UNITED STATES PATENT AND TRADEMARK OFFICE

APPLICATION NO.	FILING DATE	FIRST NAMED INVENTOR	ATTORNEY DOCKET NO.	CONFIRMATION NO.
10/774,597	02/10/2004	Sean R. Sykora	20344.00	8881

Office Action Summary

DETAILED ACTION

Fig. 4

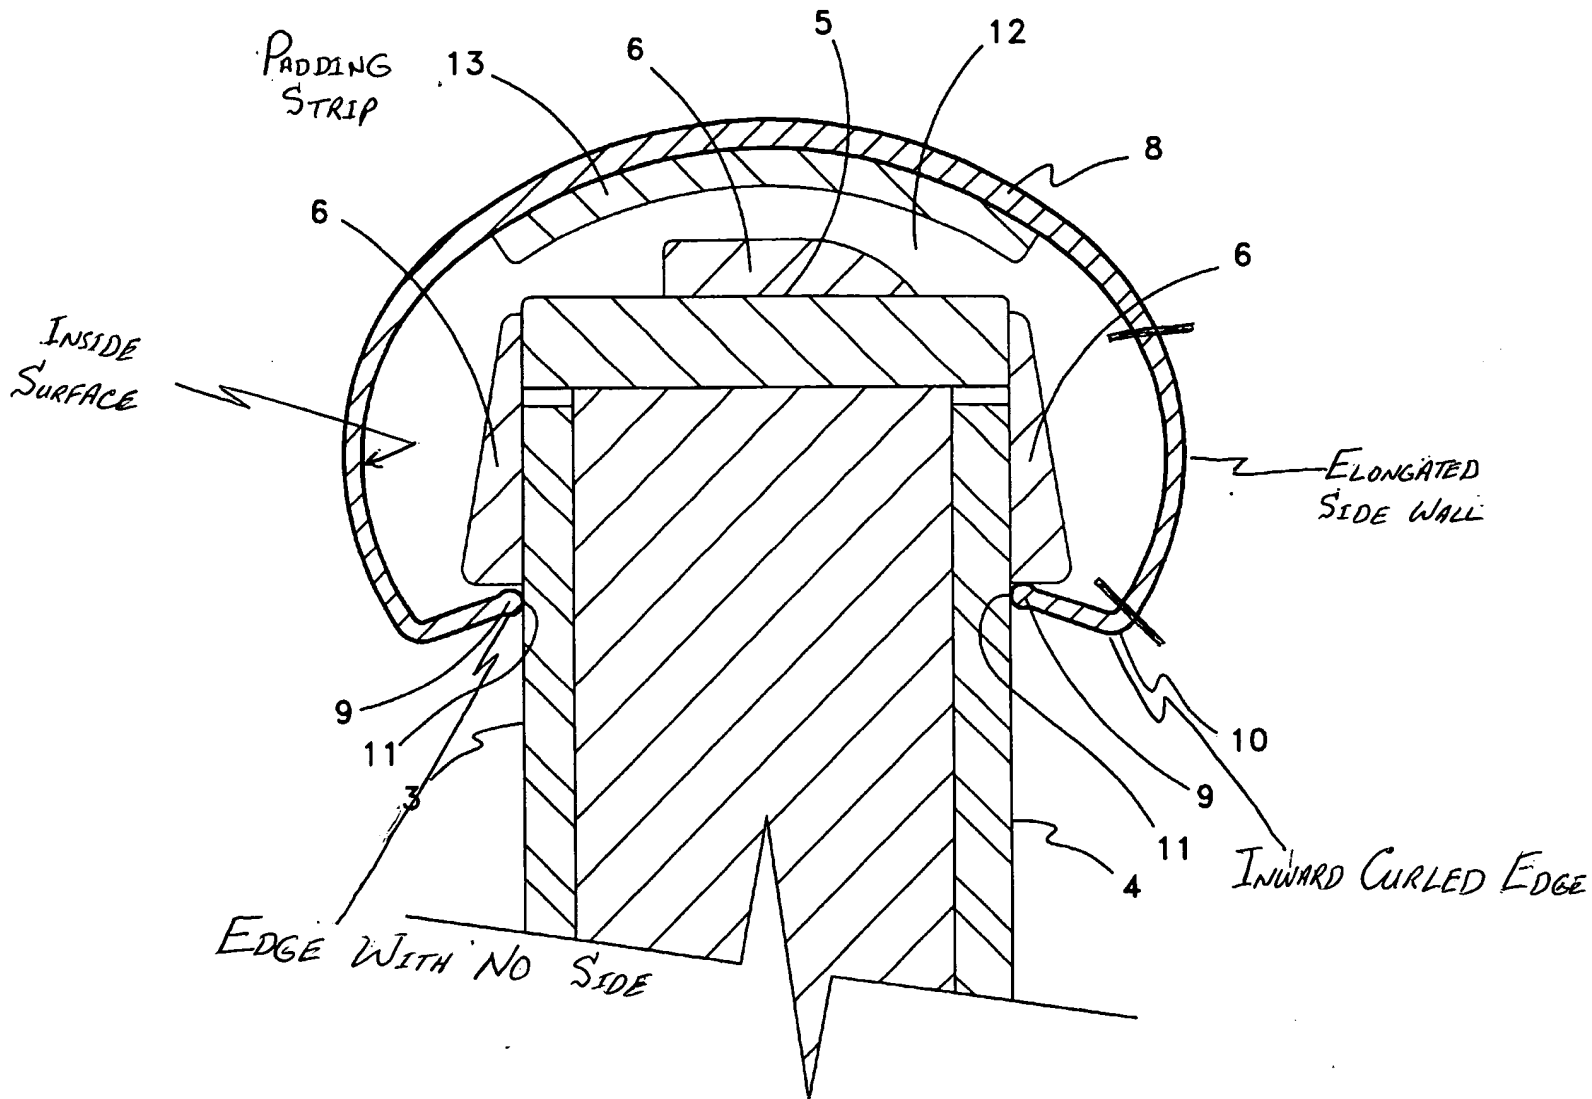
In regard to claim 2, Homolka discloses a doorframe protector comprising at least one strip 13 of padding material disposed longitudinally along the inside surface (see Fig. 4).

In regard to claim 5, Homolka discloses a doorframe protector comprising at least one strip 13 of padding material disposed longitudinally along the inside surface (see Fig. 4).

In regard to claims 10 and 11, Homolka discloses a doorframe protector comprising at least one strip 13 of padding material disposed longitudinally along the inside surface of the latch-side protector and or the hinge-side protector (see Fig. 4).

Fig. 9

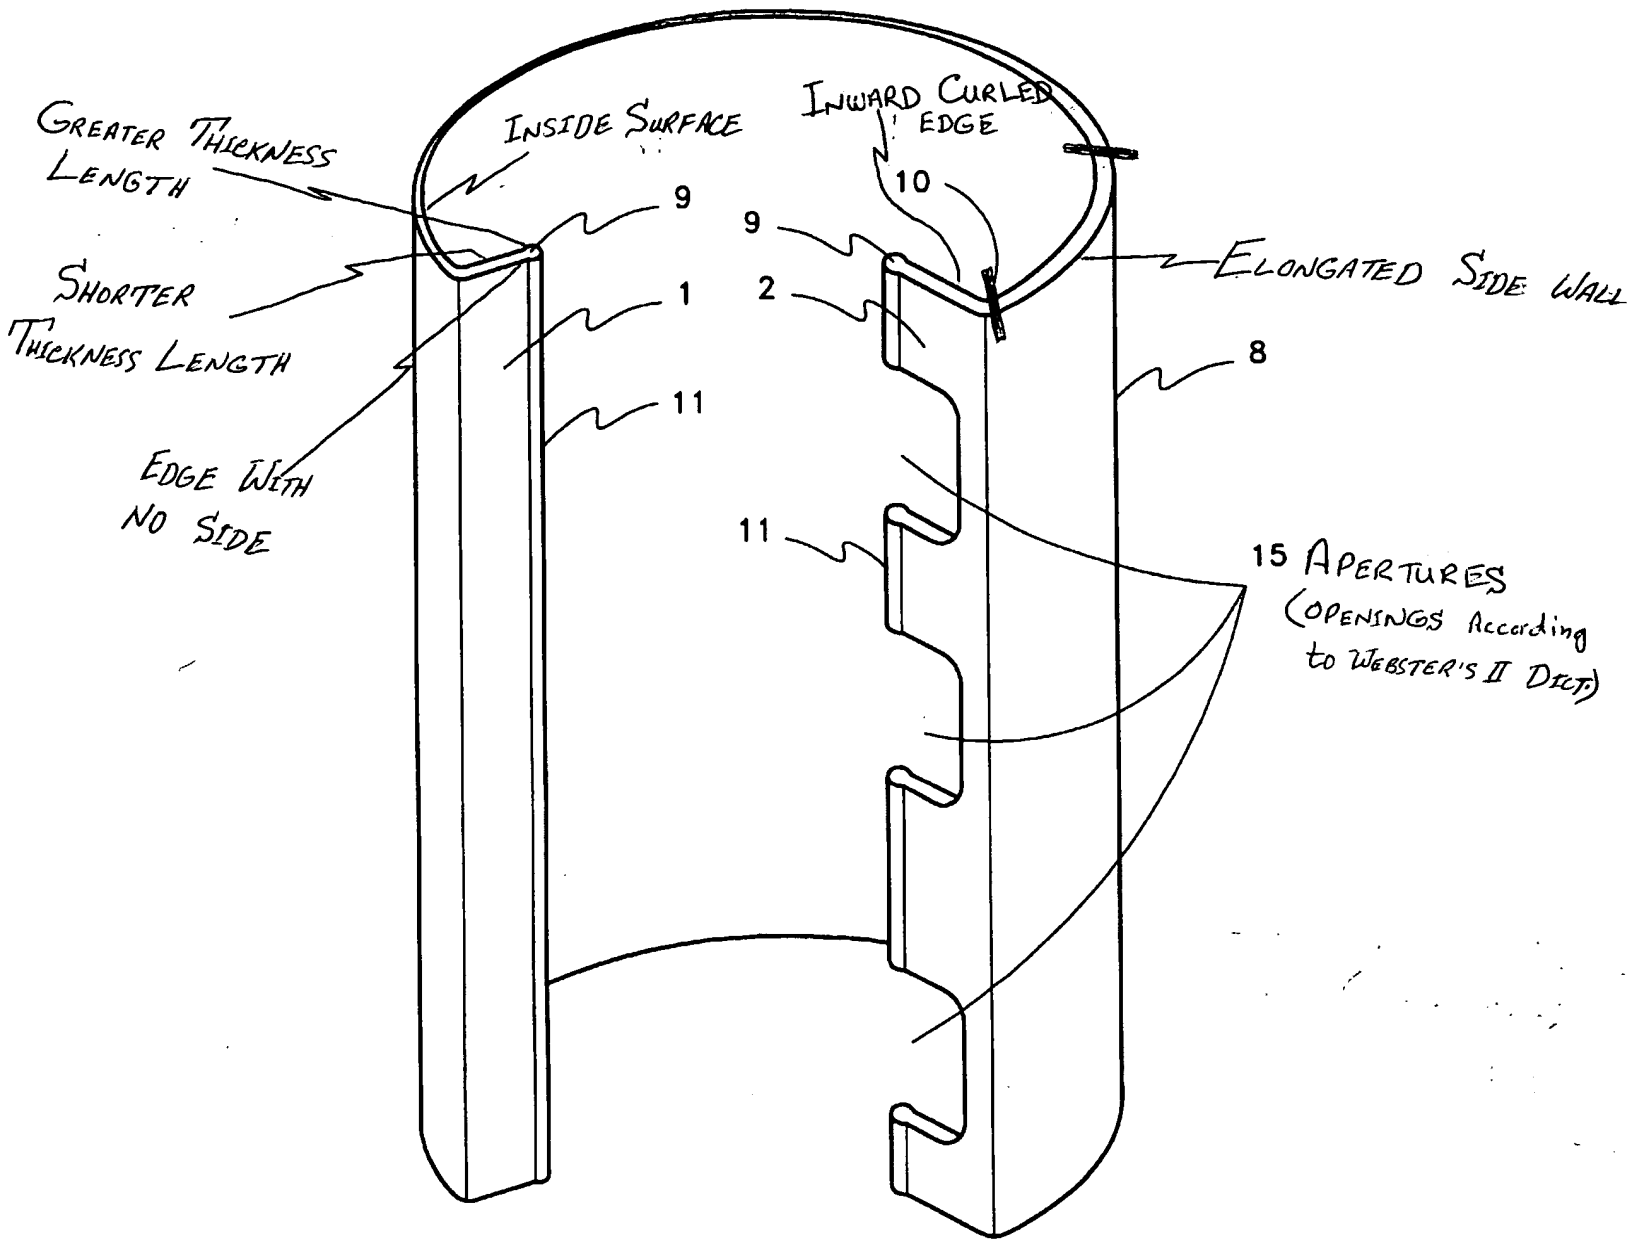
In regard to claim 1, Homolka discloses a doorframe protector (Fig. 9) comprising an elongated, flexible (column 5, lines 40-43) latch-side protector having an inside surface (see Marked Figure), the latch-side protector having pair of opposing longitudinal side walls (see Fig. 4), each of the side walls having an edge curled inward toward the inside surface (see Marked Figure).

In regard to claim 3, Homolka discloses a doorframe protector comprising a plurality of apertures 15 (Webster's II Dictionary definition) defined in and longitudinally spaced along the side wall (see Fig. 9).

In regard to claim 4, Homolka discloses a doorframe protector (Fig. 9) comprising an elongated, flexible (column 5, lines 40-43) hinge-side protector having an inside surface (see Marked Figure), the hinge-side protector having a first longitudinal side wall (see Fig. 9), having an edge curled inward toward the inside surface (see Marked Figure), the hinge-side protector having a side-less edge (see Marked Figure) opposite the side wall.

In regard to claim 7, Homolka discloses a doorframe protector comprising a second (see Fig. 9) longitudinal side wall disposed along the side-less edge, the second side wall having an edge curled inward toward the inside surface (see Marked Figure), the second side wall having a length substantially shorter than the length of the side-less edge (see Marked Figure).

In regard to claim 8, Homolka discloses a doorframe protector comprising the second side wall centered along the side-less edge (see Marked Figure).

In regard to claim 9, Homolka discloses a doorframe protector (Fig. 9) comprising an elongated, flexible (column 5, lines 40-43) latch-side protector having an inside surface (see Marked Figure), the latch-side protector having pair of opposing longitudinal side walls (see Fig. 4), each of the side walls having an edge curled inward toward the inside surface (see Marked Figure); and elongated, flexible (column 5, lines 40-43) hinge-side protector having an inside surface (see Marked Figure), the hinge-side protector having a first longitudinal side wall (see Fig. 9), having an edge curled inward toward the inside surface (see Marked Figure), the hinge-side protector having a side-less edge (see Marked Figure) opposite the side wall.

In regard to claim 12, Homolka discloses a doorframe protector comprising a plurality of apertures 15 (Webster's II Dictionary definition) defined in and longitudinally spaced along the side wall of the latch-side protector (see Fig. 9).

In regard to claim 14, Homolka discloses a doorframe protector wherein the hinge-side protector comprises a second (see Fig. 9) longitudinal side wall disposed along the side-less edge, the second side wall having an edge curled inward toward the inside surface (see Marked Figure), the second side wall having a length substantially shorter than the length of the side-less edge (see Marked Figure).

In regard to claim 15, Homolka discloses a doorframe protector comprising the second side wall centered along the side-less edge (see Marked Figure).

HINGE-SIDE PROTECTOR (SECURING PEECE)
AND/OR
LATCH-SIDE PROTECTOR
